EMERGENCY PLAN IMPLEMENTING PROCEDURE

EM-225C

POST ACCIDENT MONITORING OF REACTOR BUILDING TEMPERATURE
(This Procedure Addresses EQ Components)

Procedure: EM0225C

Enclosure 1

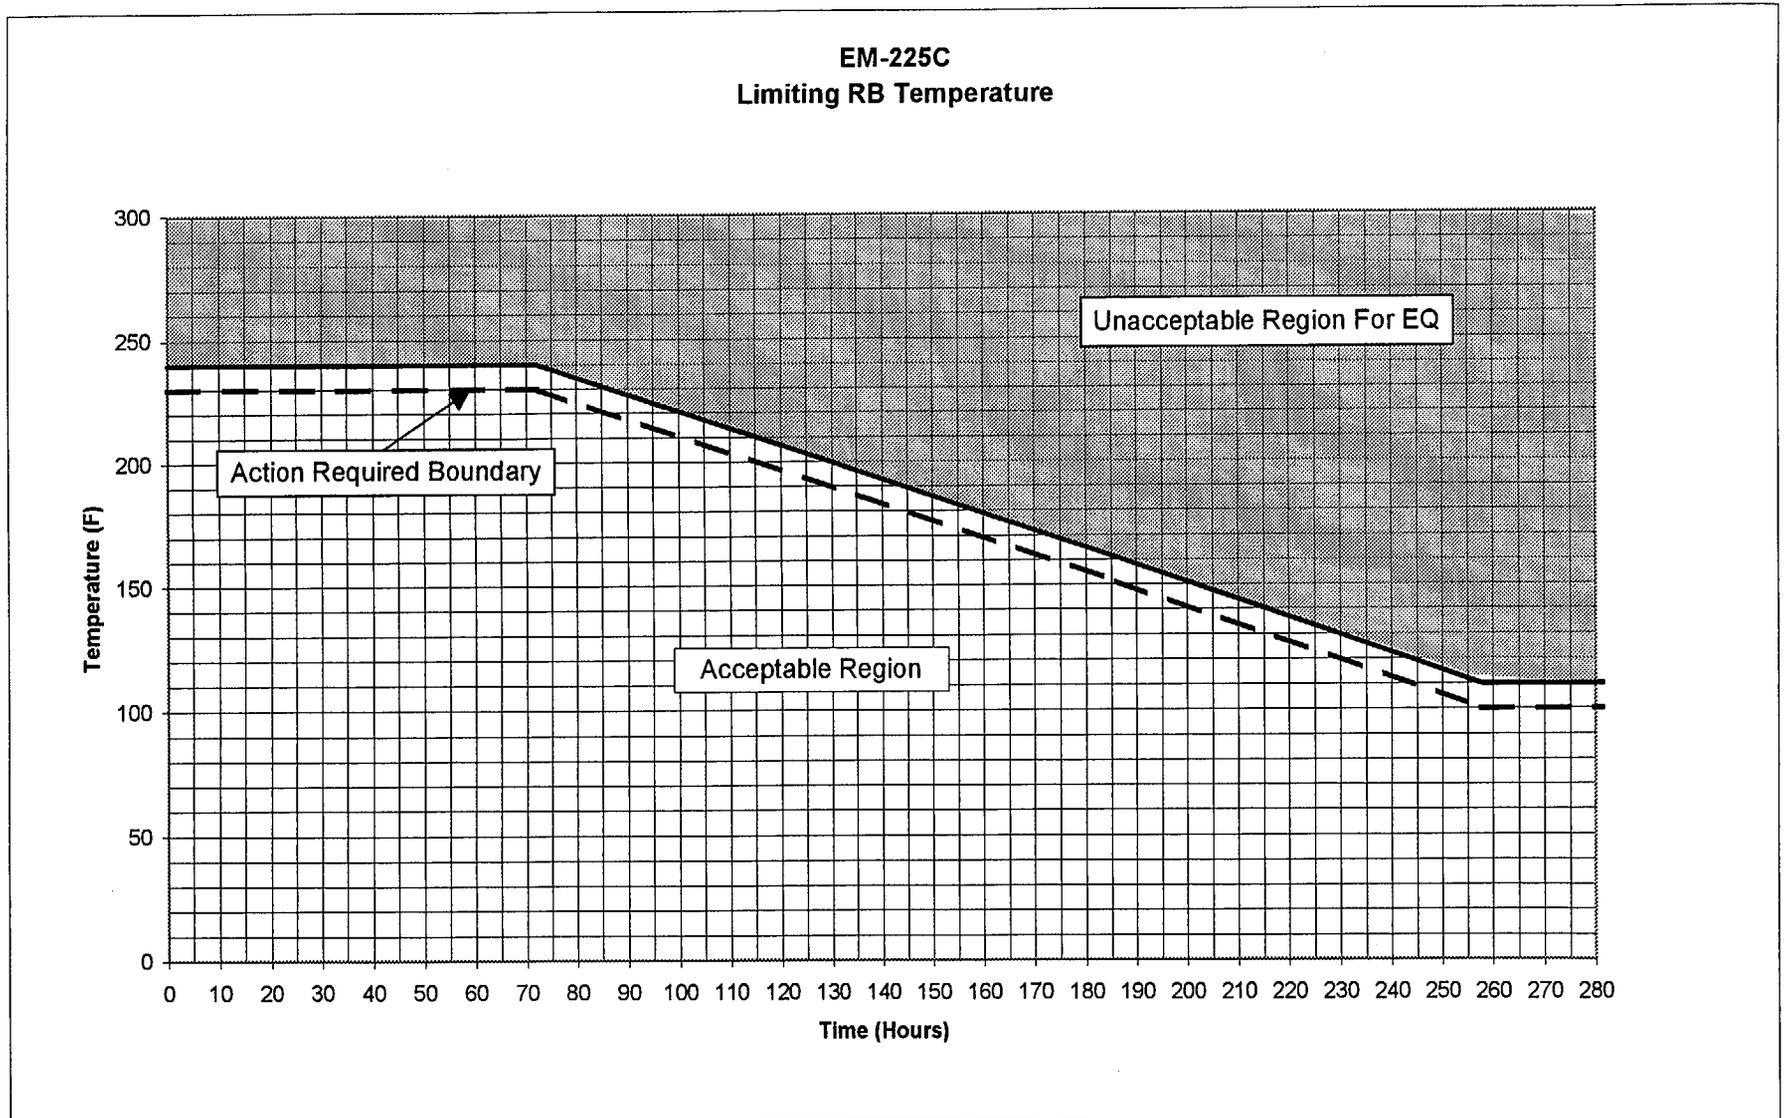
Pc 00-0830 identified a deficiency that EM-225C did not fully implement the required RB temperature threshold limits identified in IOC NOE 97-2534. Revised Enclosure 1 to meet the IOC requirements. Revised the action band from 25 deg to 10 deg. 25 deg band was a large margin band to take action. 10 deg is an adequate margin to take action. The temperature rise will be slow and time is available to plan for the required actions. Also several human factors enhancements were incorporated into the enclosure. (i.e. region names changed, shading, extend the curve)
